# Hornsea Project Four

**Applicant's response to the Rule 17 request  
dated 14 April 2022 and submission in respect of  
bp's technical evidence**

**Deadline: 5, Date: 20 June 2022  
Document Reference: G5.21  
Revision:01**

Appendix A Report of Andrew Sewell, Xodus

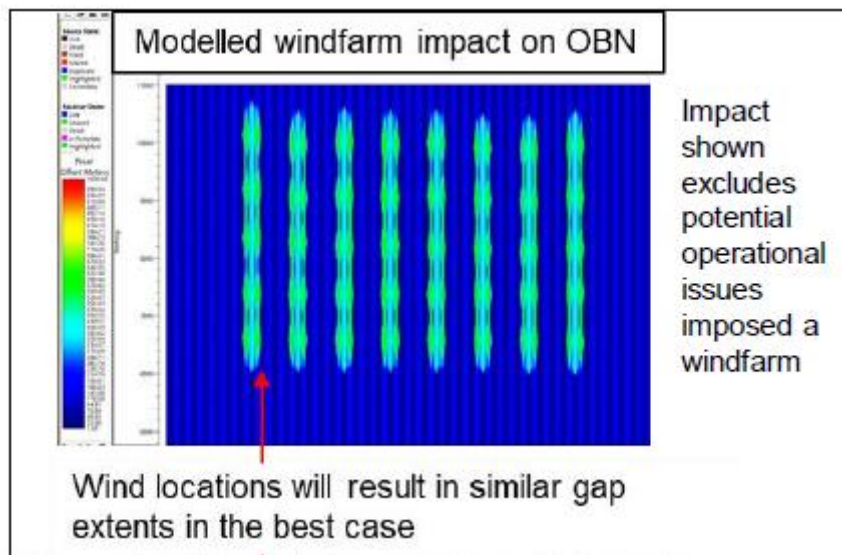
On slide 3, bp makes statements about the data quality, unproven use and cost of OBN technology which are more definite than is justified. OBN is only poorer data quality than towed streamer if one makes certain assumptions about source and receiver geometries. It does not acquire inherently poorer quality data than towed streamer. In fact on slide 4 bp highlights that it has *"applied the technology to the most of its major oil and gas fields"* and OBN has been used for acquiring high resolution data in many parts of the world [17] [18]. All seismic acquisition systems are unproven for use within a large wind farm. The actual cost comparison between OBN and towed streamer will depend on the survey designs used and can be calculated more accurately than *"up to ...."* during a detailed survey evaluation and design study.

bp is a party to various efforts underway to develop technologies that may improve OBN efficiency and thereby reduce the costs of such operations. The autonomous and uncrewed node technologies, shown on slide 5 will be aimed at reducing cost rather than having an impact on data quality per se. I agree with bp's conclusion that these cannot be relied upon as making a difference in the near term for Endurance.

Figure 25: Detectability of CO<sub>2</sub> in thin beds. The seismic response is shown in tracks '4D Nrs and 4D Frs' (Nears = 10° and Fars =30°). Standard resolution only detects part highlighted in green and misses the additional CO<sub>2</sub> shown in pink, which is detected at high resolution.

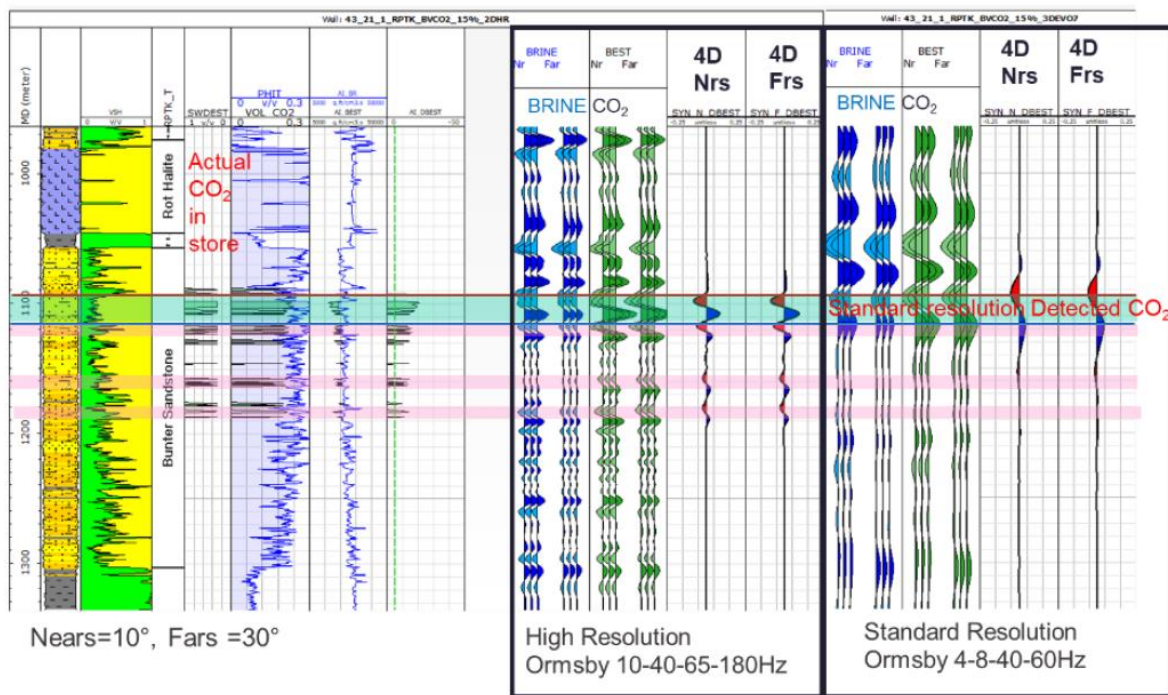
Section 7.3.1 on pages 44 – 46 outlines the requirements for 4D seismic data in relation to the highly stratified Bunter sandstone. "To simulate CO<sub>2</sub> in high porosity/permeability in thin beds a fluid substitution was carried out with a porosity cut off at 28%" as shown in figure 25 in bp's report, reproduced below and in Sutherland et al [27]. bp goes on to say "whilst any standard resolution seismic will detect thicker layers of CO<sub>2</sub>, the thinner layers only show a 4D response .... at high resolution". This describes standard resolution vs high resolution in terms of temporal frequencies. But the issue under discussion is the spatial sampling of OBN compared to streamer. In this report bp is only showing how spatial sampling affects temporal bandwidth for 2D high resolution (2DHR) towed streamer compared to 3D conventional towed streamer. There is no reason to assume that OBN data would have the same bandwidth as the 2013 conventional 3D streamer data, as implied by bp. Sutherland et al [27] gives more details on the fluid substitution modelling and how the bandpass filters were derived from analysis of 2D high resolution test lines acquired over Endurance in 2020. I propose that this work should be expanded to include synthetic seismic datasets from different survey designs (OBN and others) for comparison.

Figure 26: Example of high resolution towed streamer data over Endurance

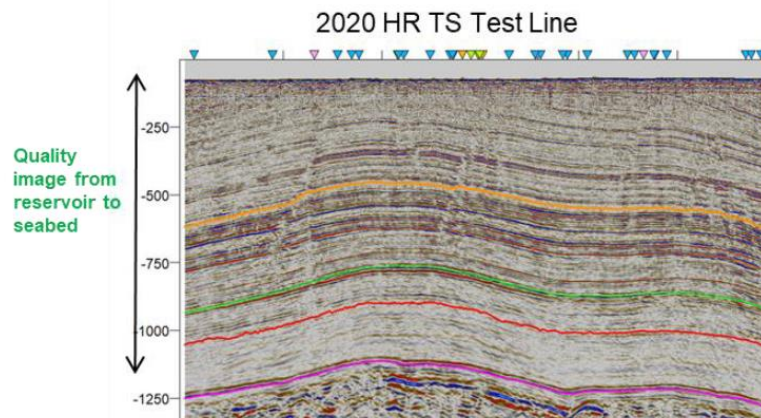
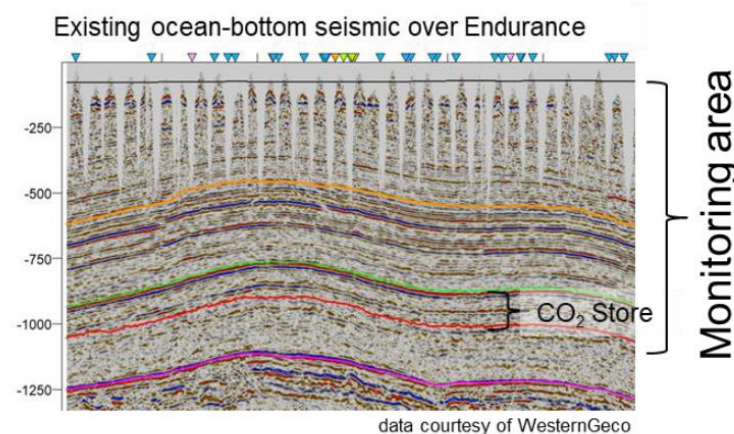
bp then goes on to compare one of the 2020 high resolution 2D test lines with a 1997 sparse 3D OBC line in an attempt to demonstrate the differences in data quality between different data acquisition methods. This is shown in figures 26 and 27 which are reproduced below. As can be seen, the sparse line OBC data does not have good coverage in shallow section and has lower signal-to-noise ratio at the Bunter level. This is not a like for like comparison and therefore not a fair representation of OBN vs towed streamer for the issues under discussion.

Figure 30: Modelled near offsets with wind turbine exclusion zones

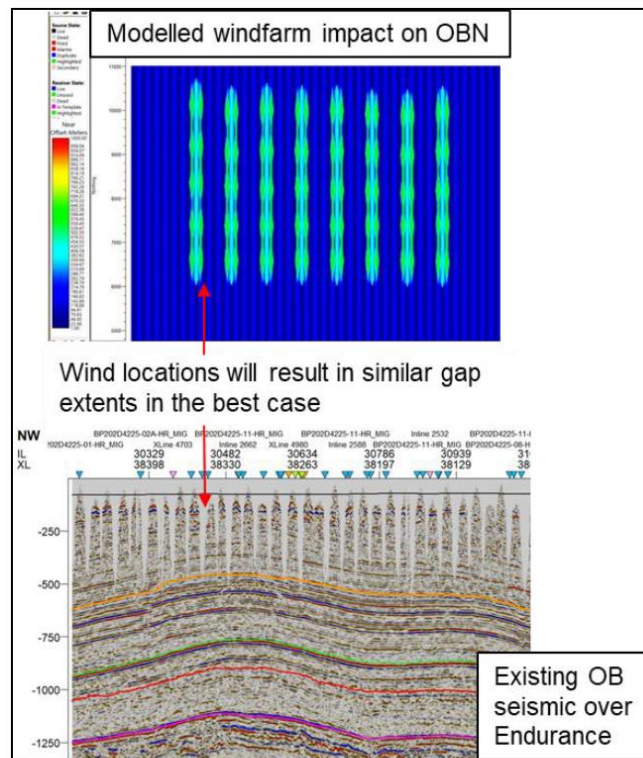
The figure above is shown on slide 9 and also appears in bp’s technical assessment [5] as Figure 30. It appears to show the nearest offset in each subsurface bin. It is not explained how this map was created but the vertical stripes would imply that sources were acquired in one azimuth only. It would be useful for bp to explain this map in more detail and whether maps from other possible acquisition templates were created for comparison.

On page 49, bp compares the option of a sparse vs dense OBN survey over Endurance. However it does not define the parameter range assumed for "sparse" or "dense" OBN. How did bp generate the "modelled windfarm impact" in Figure 30 of its report (reproduced below)? What assumptions were made on source and receiver spacing? In reality, there is a continuum between "sparse" and "dense". There is no reason to think that OBN will not produce good 4D results, given that it usually gives high quality 3D results when used in the oil and gas industry [18].

Figure 34: Example of variation in current direction and strength in the area (yellow box) over a 24-hour period (22/09/21)

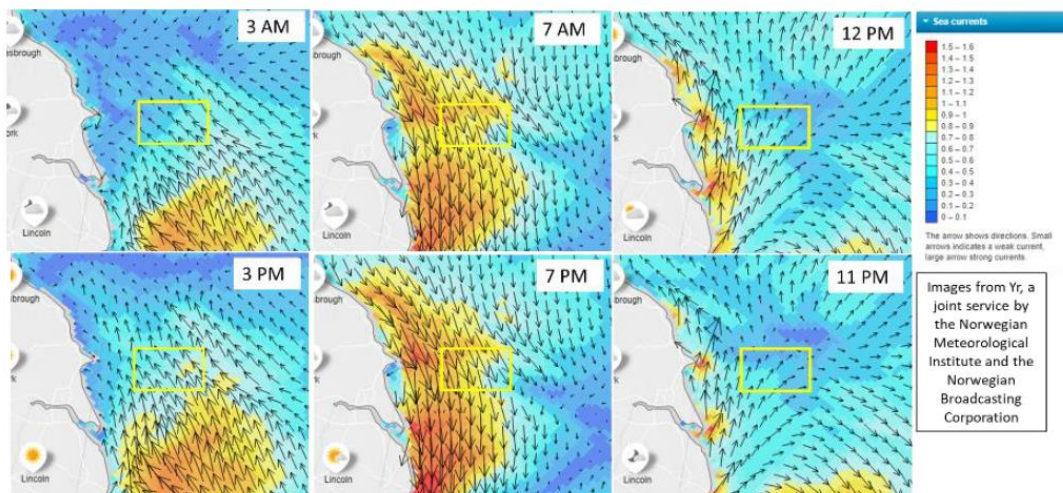
Section 7.3.3 and Figure 34 (reproduced below) describe the challenges related to strong currents in the Endurance area. bp states *"Acquisition in the area around Endurance is complicated by the strong tidal currents. The maps below illustrate the change of direction of the dominant current every 12 hours. This will make sailing the seismic source boat along specific lines inside the windfarm difficult. We anticipate that at least 25% extra time will be required for weather restrictions and difficulty in achieving matched source-receiver pairs for accurate 4D differencing."* Data acquisition problems related to strong tides are going to be worse for streamers compared to OBN when it comes to matching source-receiver pairs between survey, whether or not there is a wind farm in place.

Fig. 4. Fold map of (a) 1994 dataset and (b) 2006 dataset.

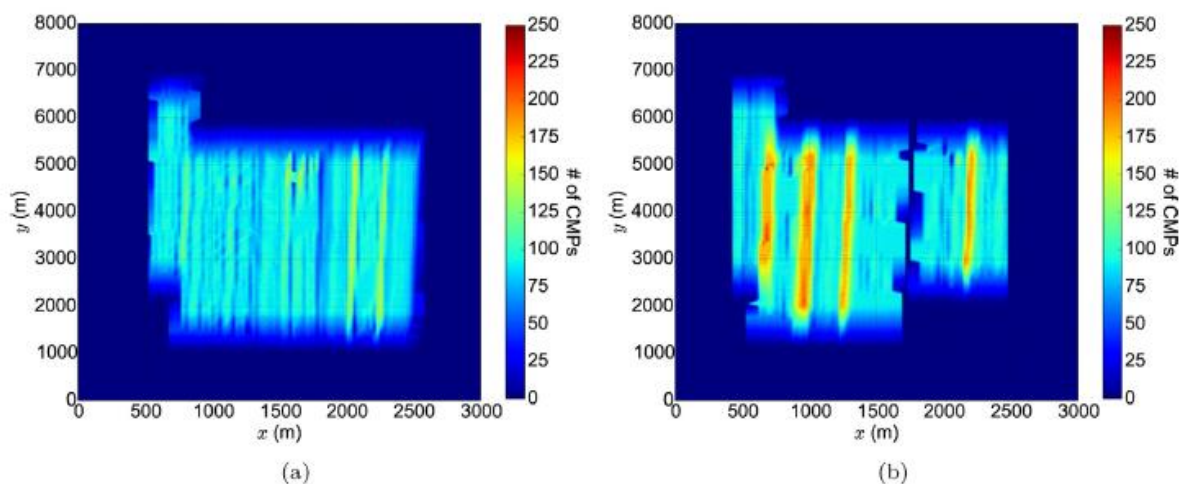
The following image taken from [13], Raknes et al, 2015, shows the fold of coverage of the Sleipner baseline survey in 1994 compared to the repeat survey in 2006. Fold of coverage is a proxy for s/n. As can be seen the fold maps are quite different. Nevertheless the 2006 survey still provided useful CO<sub>2</sub> monitoring data.
